USHGC[®] TECHNICAL COMMITTEE MEETING MONOGRAPH

**2026 Uniform Solar, Hydronics & Geothermal Code
Technical Committee Meeting
IAPMO World Headquarters, Ontario, CA
May 12, 2026**

FIGURE 412.4.1.1

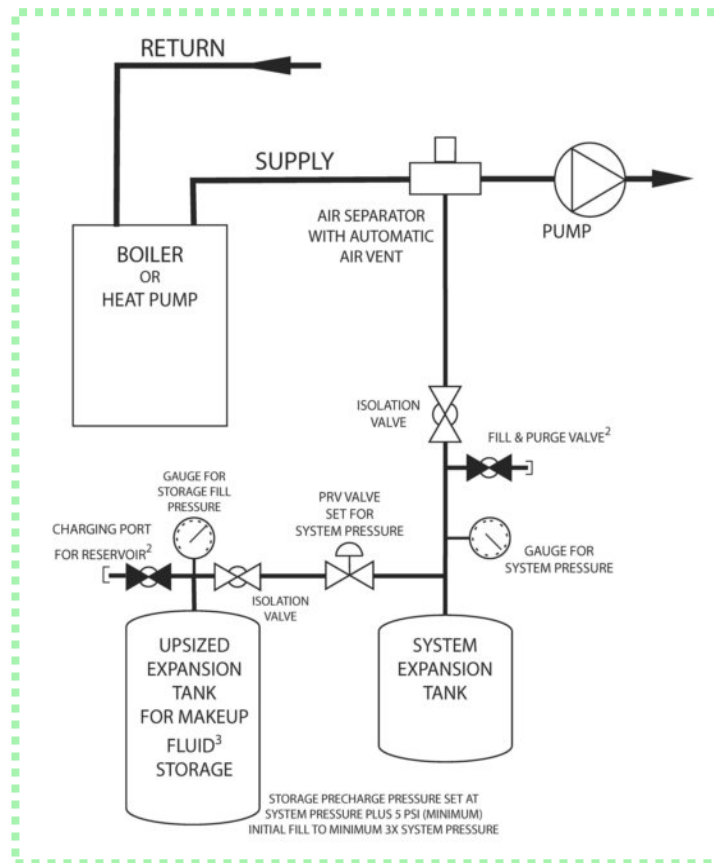
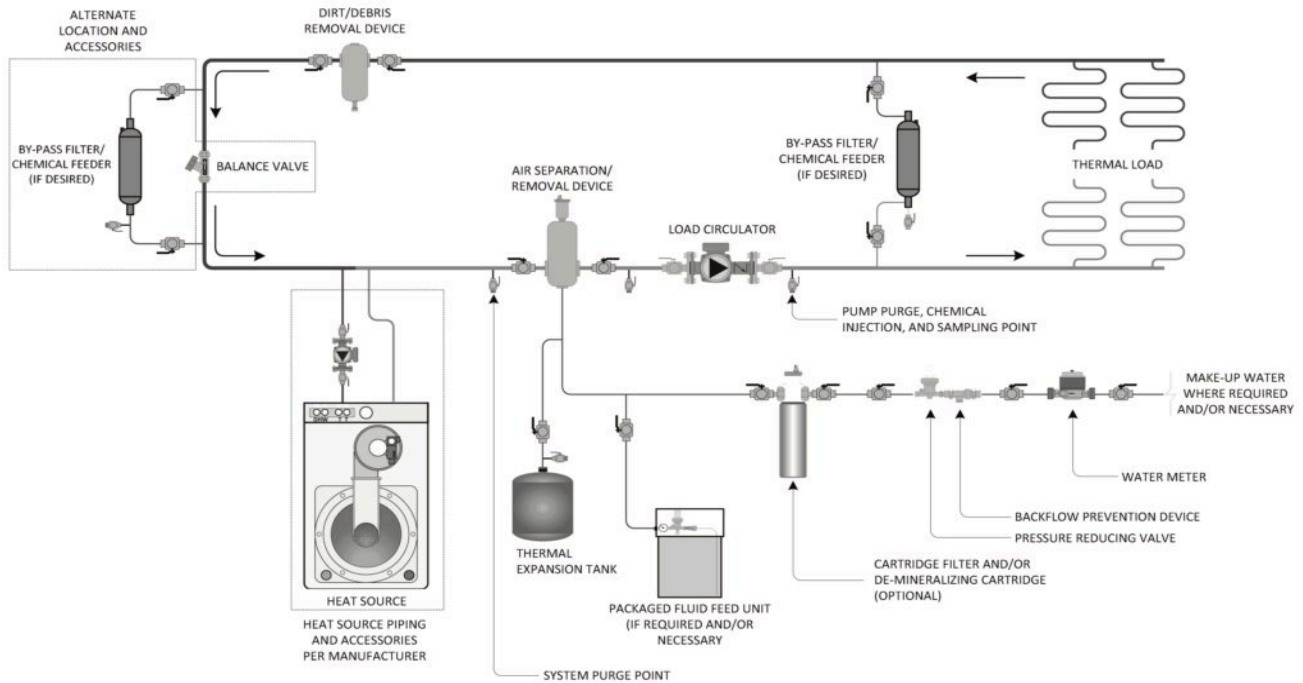
By incorporating IAPMO/ANSI H1001.1 into the code as a requirement, system water quality is now mandated, with implications for the makeup supply. The included limitation of no more than 5% makeup by volume, without manual intervention, has several purposes. This ensures basic system fluid quality, controls dilution in systems with antifreeze or chemical additives, and has the added benefit of limiting consequential water damage in the event of a breached or damaged system. It is important to differentiate between the use of potable water (of acceptable quality standards) and a connection to a potable (pressurized) water supply (also only if of acceptable water quality). The general thrust of this ANSI standard is toward isolation of hydronic systems from a potable water supply, which is encouraged by the use of system pressurization units or reservoirs. This should be further encouraged by placing equivalent makeup volume limitations on potable water supply makeup systems as well, for all the previously stated reasons.

Research shows that undamaged hydronic systems will typically require a maximum of about 0.5% makeup fluid by volume annually. It is also shown that municipal water supplies are typically under 2% entrained air by volume. The 5% makeup allowance can easily replace the entrained air volume that is extracted after startup and will typically still provide at least five years of makeup supply requirements. Therefore, this limitation is not an undue burden on the installer or facility owner, nor is it a boiler safety issue, due to the code requirements for low water cutoff or flow monitoring for boiler shutdown. It should be noted that many systems, particularly in Europe, operate very successfully with no automatic makeup supply at all. As the installation of an automatic makeup system is, in fact, discretionary, there should also be discretion allowed regarding a path to code compliance.

412.4 Automatic Makeup Fluid. Automatic makeup fluid shall be in accordance with Section 412.4.1 for potable water makeup fluid or Section 412.4.2 for nonpotable makeup fluid. Where an automatic makeup fluid supply fill device is used to maintain the fluid content of a closed loop hydronic system, or any closed loop in the system, the makeup supply source shall introduce the makeup fluid at the expansion tank or other approved location. A pressure reducing valve or pressure control system shall be installed on the makeup feed line. The pressure of the makeup feed line shall be set in accordance with the design of the system. Makeup fluid supplied to the system shall be in accordance with Section 401.6 and be equivalent to or consistent with the installed hydronic system fluid. Automatic makeup fluid systems shall be in accordance with Section 412.4.1 or Section 412.4.1.1 for potable water makeup fluid or Section 412.4.2 for nonpotable makeup fluid.

412.4.2 Nonpotable Makeup Fluid. Makeup fluid systems that are designed to add pre-mixed antifreeze solutions shall be permitted. Such systems shall include, but not be limited to, glycol feeders and limited volume reservoir systems. On systems using additives, such as glycol or corrosion inhibitors, the use of a system pressurization unit or glycol feeder shall be required. The fluid capacity of the tank or reservoir shall not exceed the greater of 5 gallons (19 L), or 5 percent of the total system fluid volume.

FIGURE 412.4.1.1

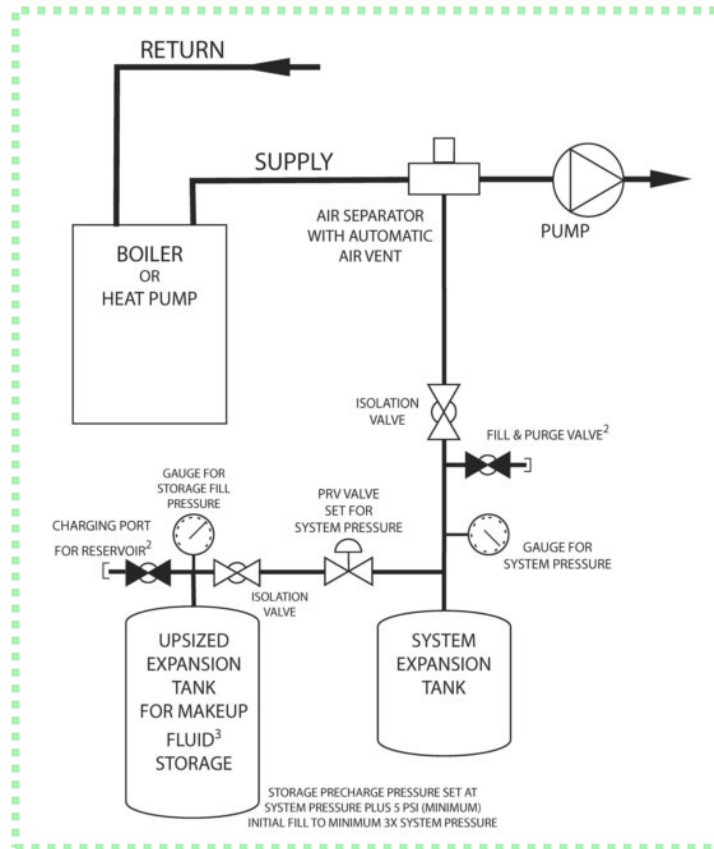
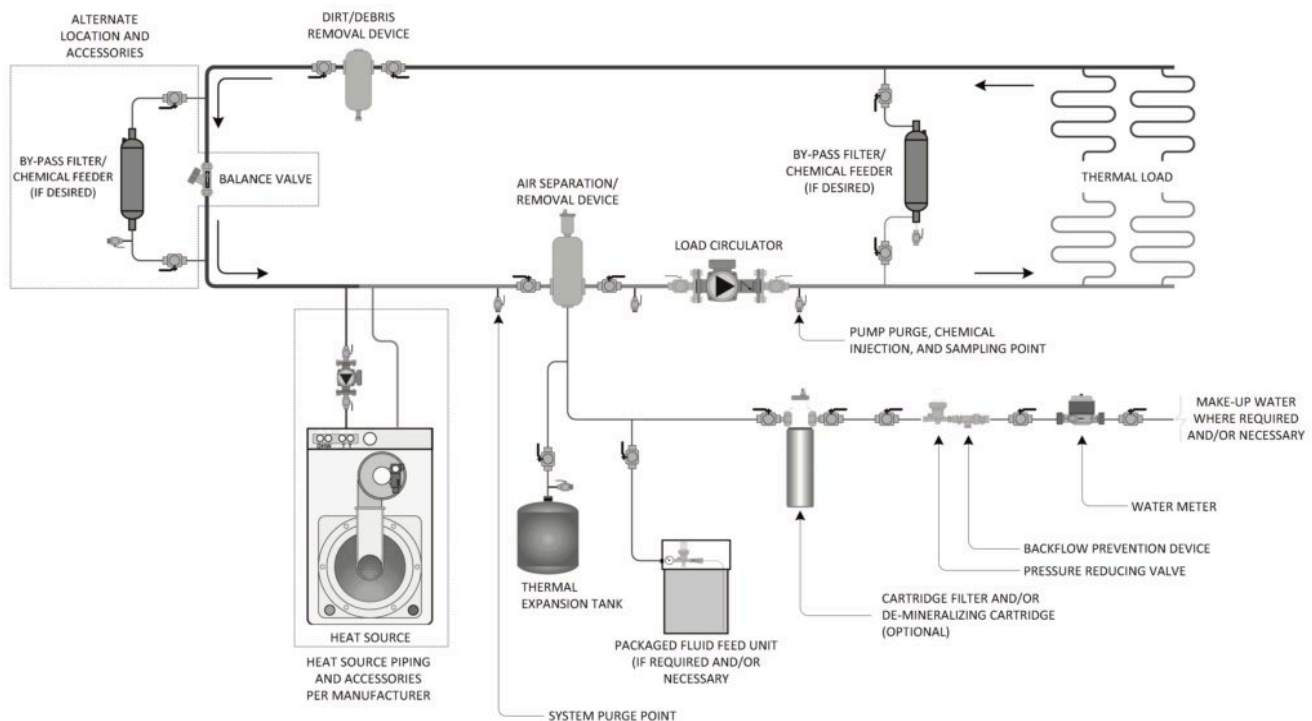
By incorporating IAPMO/ ANSI H1001.1 into the code as a requirement, system water quality is now mandated, with implications for the makeup supply. The included limitation in the standard of no more than 5% makeup by volume, without manual intervention, has several purposes. This ensures basic system fluid quality, controls dilution in systems with antifreeze or chemical additives, and has the added benefit of limiting consequential water damage in the event of a breached or damaged system.

412.4.2 Automatic Makeup Fluid for Systems Using Nonpotable Water. Where the hydronic system is filled with a nonpotable fluid, such as an antifreeze solution, or incorporates a chemical feeder, there shall be no direct or permanent connection to the potable water system. A system pressurization unit or reservoir system shall be required as the source for makeup fluid. The fluid capacity of the pressurization unit or reservoir system shall not exceed 5 gallons (19 liters) or 5 percent of the total system volume, whichever is greater. Where a temporary connection to a potable water supply system is required, backflow protection shall be provided in accordance with Section 402.3.

(1) Where the volume of supplied makeup fluid is continuously monitored by permanently installed system controls, the volume limitation shall not be required.

(2) Where a chemical feeder is installed on a system otherwise filled with potable water, an automatic makeup fluid system shall be permitted to be installed in accordance with Section 412.4.1. [See Figure E 102.1(1) for an example of a simplified schematic of a potable water supply makeup system feeding a system filled with potable water.]

FIGURE 412.4.1.1

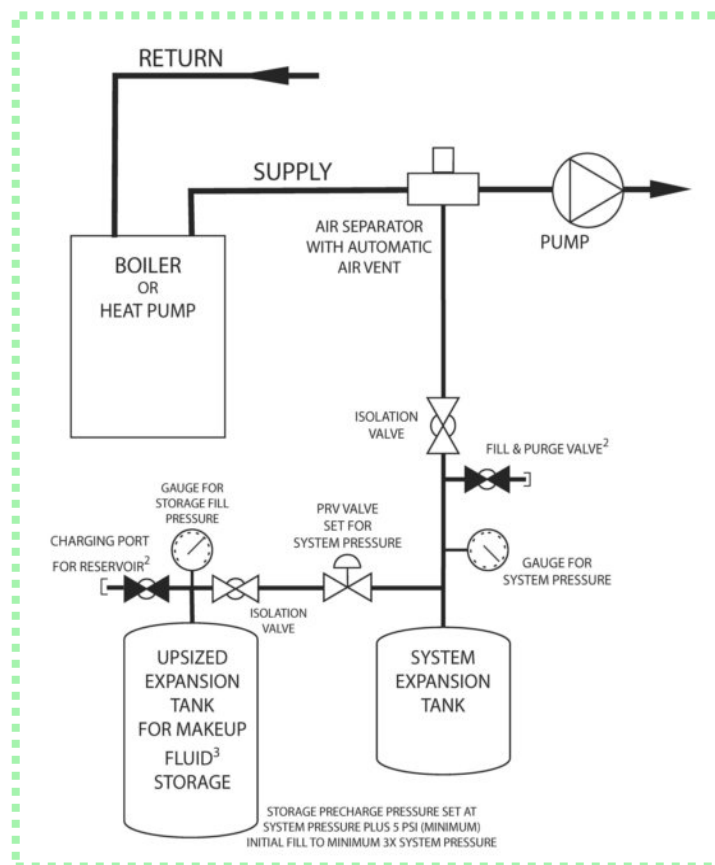
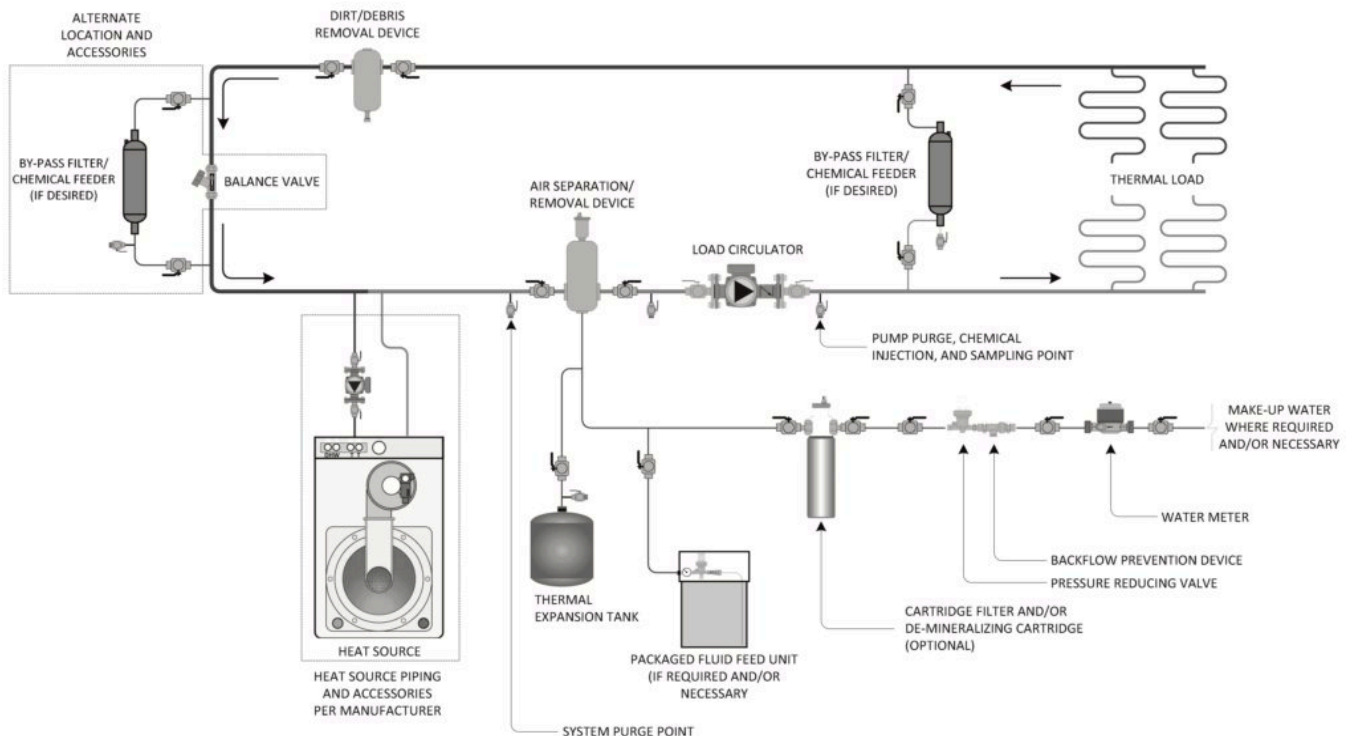
Item #: 067	Code Number: 2024 USHGC	Sections(s): 412.4 - 412.4.2, Figure 412.4.1.1
Submitter Name: Lee Stevens	Organization Name: LH Stevens Constructors LLC	Organization Representation:

412.4.2 Automatic Makeup Fluid for Systems Using Nonpotable Water. Where the hydronic system is filled with a nonpotable fluid, such as an antifreeze solution, or incorporates a chemical feeder, there shall be no direct or permanent connection to the potable water system. A system pressurization unit or reservoir system shall be required as the source for makeup fluid. The fluid capacity of the pressurization unit or reservoir system shall not exceed 5 gallons (19 liters) or 5 percent of the total system volume, whichever is greater. Where a temporary connection to a potable water supply system is required, backflow protection shall be provided in accordance with Section 402.3.

Exception: Where a chemical feeder is installed on a system otherwise filled with potable water, an automatic makeup fluid system shall be permitted to be installed in accordance with Section 412.4.1. [See Figure E 102.1(1) for an example of a simplified schematic of a potable water supply makeup system feeding a system filled with potable water.]

**FIGURE 710.1(1)^{1, 2}
EXAMPLE OF A CLOSED-LOOP GSHP SYSTEM
COUPLED TO A GROUND HEAT EXCHANGER
(SIMPLIFIED SCHEMATIC)**

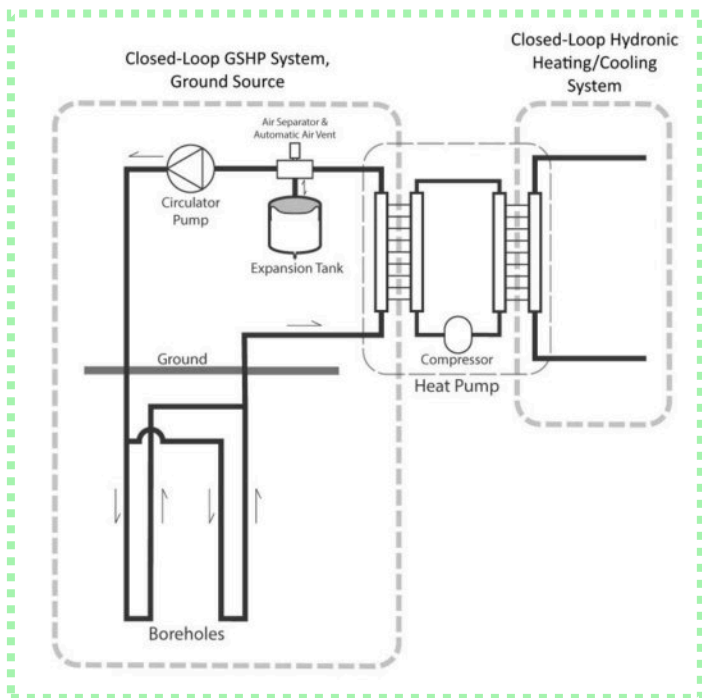
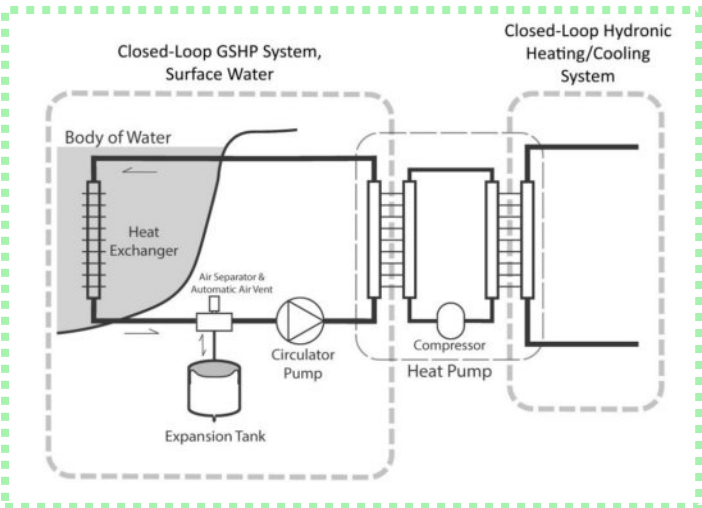
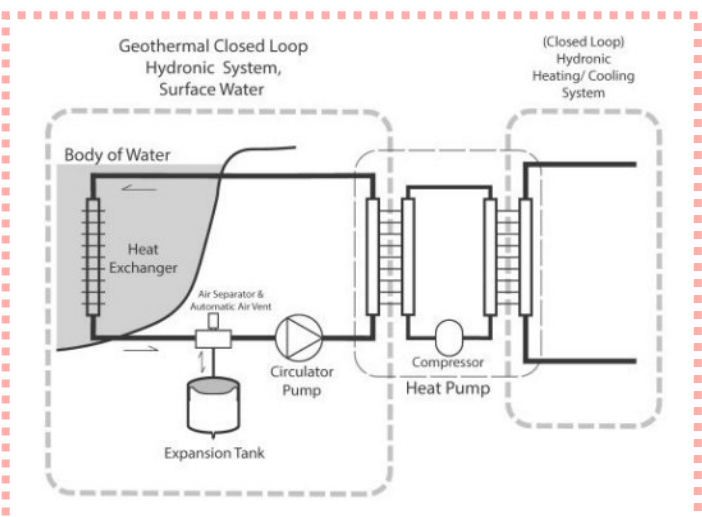
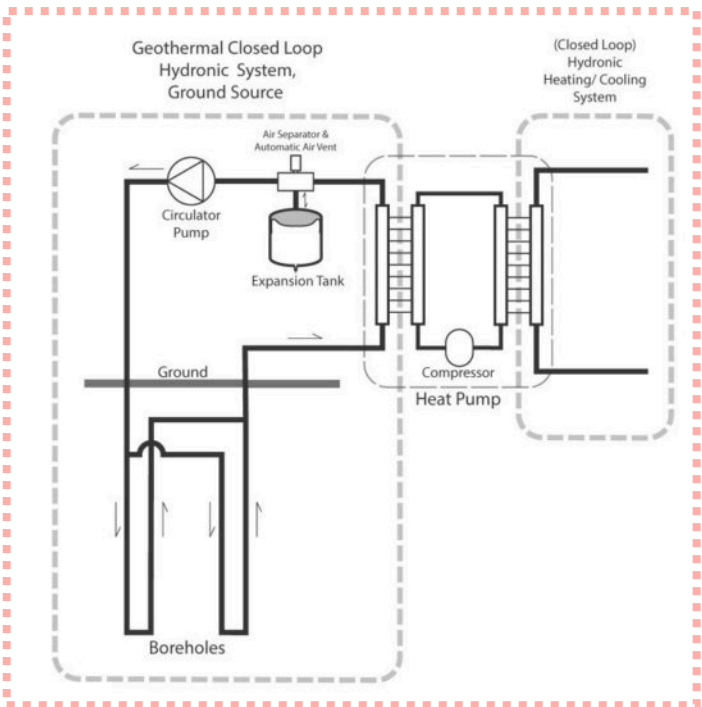
Item #: 096	Code Number: 2024 USHGC	Sections(s): 701.11.1, 710.1, Table 701.11.1, Figure 710.1(1), Figure 710.1(2)
-----------------------	-----------------------------------	---

710.1 Applicability. Part II of this chapter shall apply to closed-loop geothermal GSHP systems such as, but not limited to, systems coupled to a ground heat exchanger, or a heat exchanger submerged in a surface body of water, using water-based heat transfer fluid. [See Figure 710.1(1) for an example of a simplified schematic of a closed-loop geothermal GSHP system coupled to a ground heat exchanger. See Figure 710.1(2) for an example of a simplified schematic of a closed-loop geothermal GSHP system coupled to a heat exchanger submerged in a surface body of water.]

FIGURE 712.1(1)^{1, 2}
EXAMPLE OF AN OPEN-LOOP GSHP SYSTEM
UTILIZING SUBSURFACE WATER
(SIMPLIFIED SCHEMATIC)

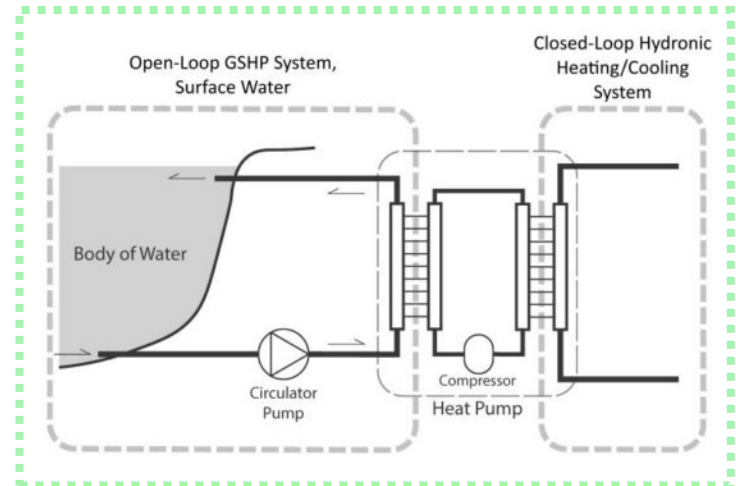
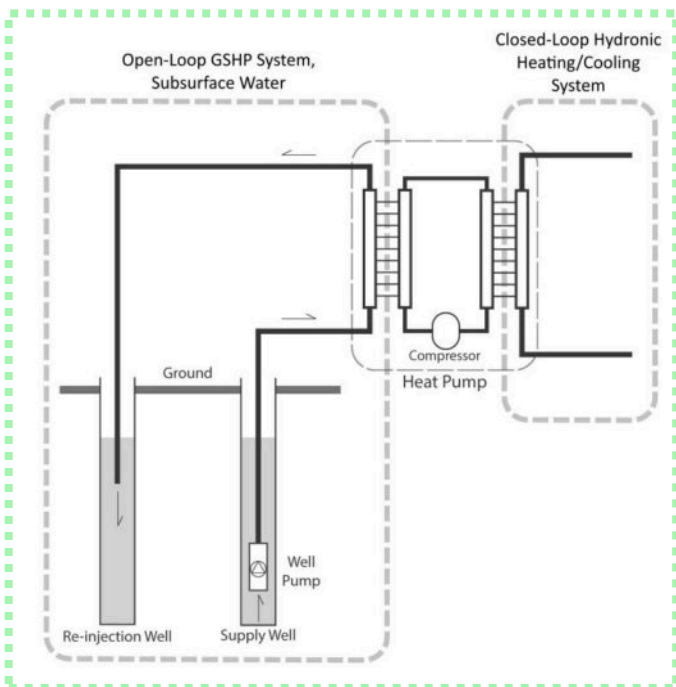
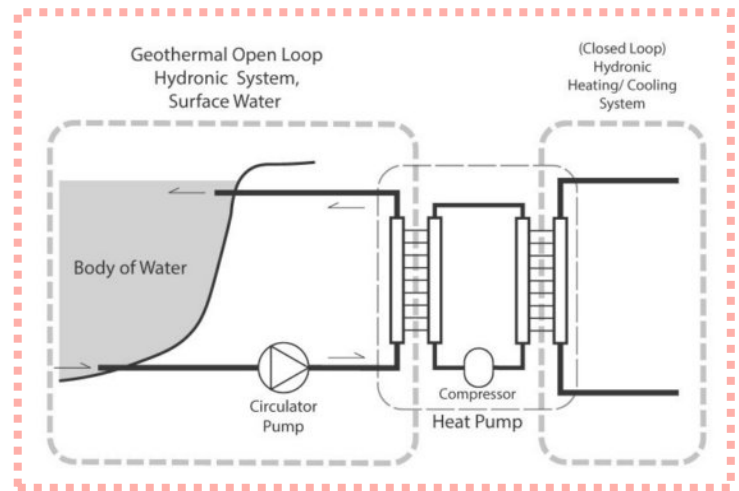
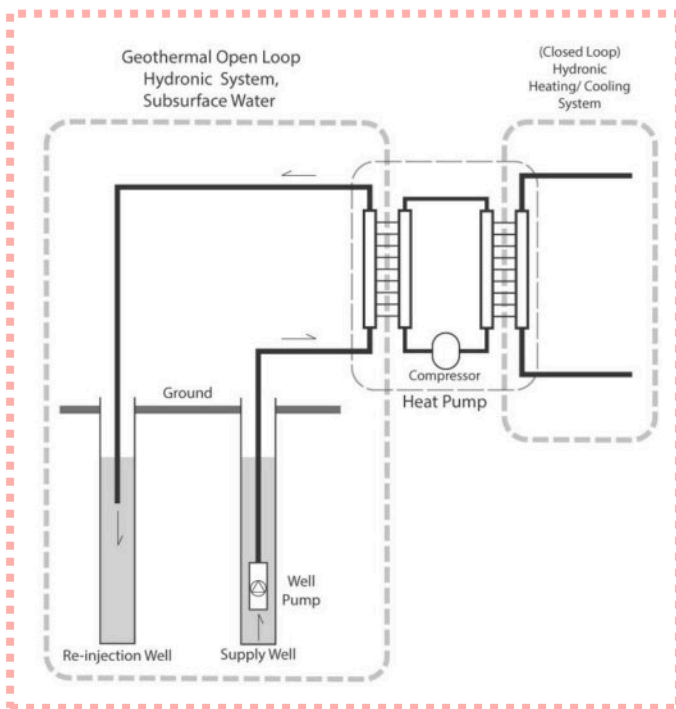
Item #: 115	Code Number: 2024 USHGC	Sections(s): 712.1, 712.2, 712.4, Figure 712.1(1), Figure 712.1(2)
-----------------------	-----------------------------------	---

712.1 Applicability. Part III of this chapter shall apply to open-loop geothermal GSHP systems ~~such as, but not limited to, systems~~ coupled to a source of groundwater (well) or surface water. Water wells shall be installed and tested in accordance with Section 713.0. [See Figure 712.1(1) for an example of a simplified schematic of an open-loop GSHP system utilizing subsurface water. See Figure 712.1(2) for an example of a simplified schematic of an open-loop GSHP system utilizing surface water.]

712.2 Materials. Components installed in an open-loop geothermal GSHP system shall be constructed of corrosion resistant materials. Materials which come into contact with potable water shall comply with NSF/ANSI/CAN 61. ~~[See Figure 712.1(1) for an example of a simplified schematic of an open-loop geothermal system utilizing subsurface water. See Figure 712.1(2) for an example of a simplified schematic of an open-loop geothermal system utilizing surface water.]~~
